**DEPARTMENT OF PLANNING
JEFFERSON PARISH, LOUISIANA**

SUBDIVISION REPORT

DOCKET NO: ES-153-16-PF	ADVERTISING DATES: 11/30/16 12/07/16
SUMMARY NO.:	12/14/16
COUNCIL DISTRICT: 5: Jennifer Van Vrancken	PAB PUBLIC HEARING: 12/22/16
COUNCIL AT LARGE: A: Christopher L. Roberts B: Cynthia Lee-Sheng	COUNCIL HEARING: LAST MEETING DATE FOR COUNCIL ACTION: 04/05/17

SUBDIVISION: Hessmer Park

FIGURE 3

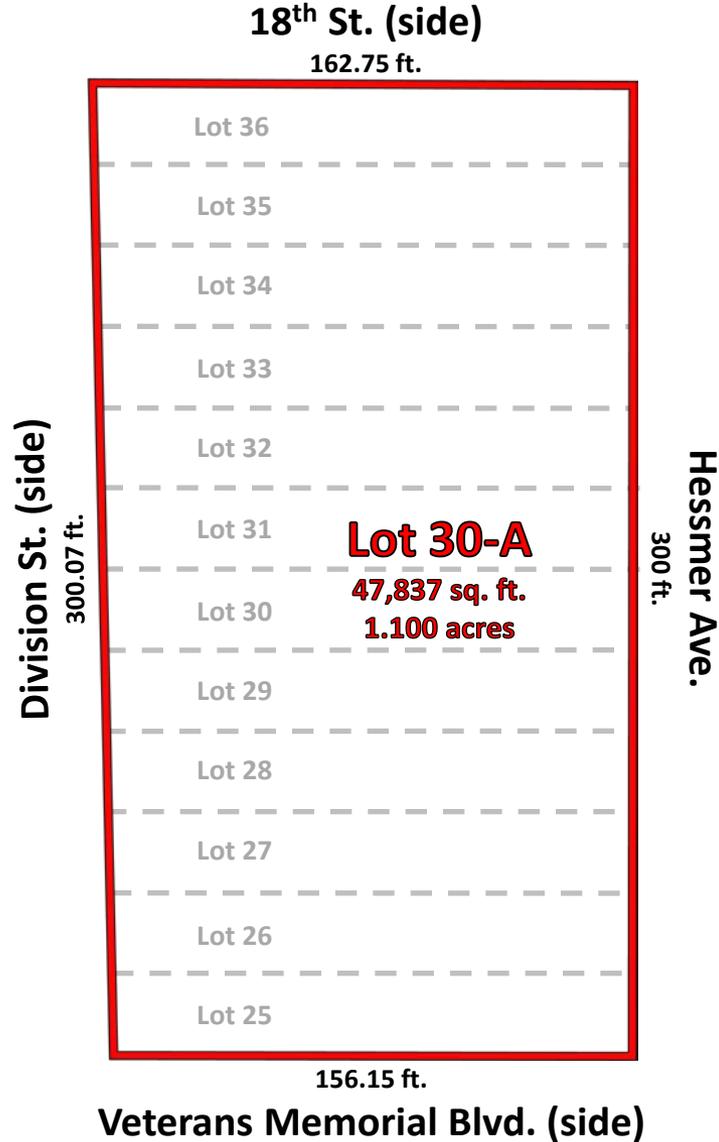
Public Works is NOT OPPOSED to this Case but has the following Stipulations: ES-153-16-PF The Department of Public Works (on 11/7/16) Requires the Planning Department to place the general stamp on the plan. The Traffic Engineering Division finds that the sight triangles are not an issue at this time and a TIA is not currently required.

ICE - Building is NOT OPPOSED to this Case but has the following Stipulations: This proposed subdivision will create split zoning. FC-1 zoning for lot 36 and FC-3 for lots 25 through 35.

Parish Attorney is NOT OPPOSED to this Case but has the following Stipulations: 18th Avenue should be 18th Street. We will defer to the other departments for additional comments.
